REMEDY FOR NOISES FROM ACCESSORY DRIVE AREA IN FORD MONDEO III AND FORD TRANSIT

TECHNICAL INFO NO. 1077

Ford | Transit, Mondeo III, Year of manufacture: 2000 - 2007

Image 1: Changing a rigid belt pulley to an over-running alternator pulley

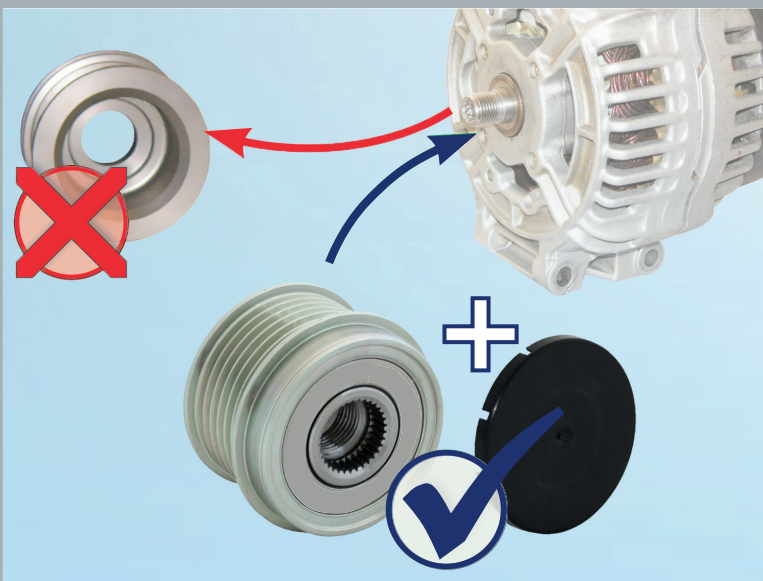
Due to the strong, dynamic movements of the V-ribbed belt, loud noises may be produced in vehicles with a rigid alternator belt pulley.

As a technical solution, RUVILLE offers an over-running alternator pulley for these vehicles. This reduces the dynamic loads in the accessory drive, thus preventing noise.

RUVILLE recommends that the vehicles affected be retrofitted with an over-running alternator pulley 59988.
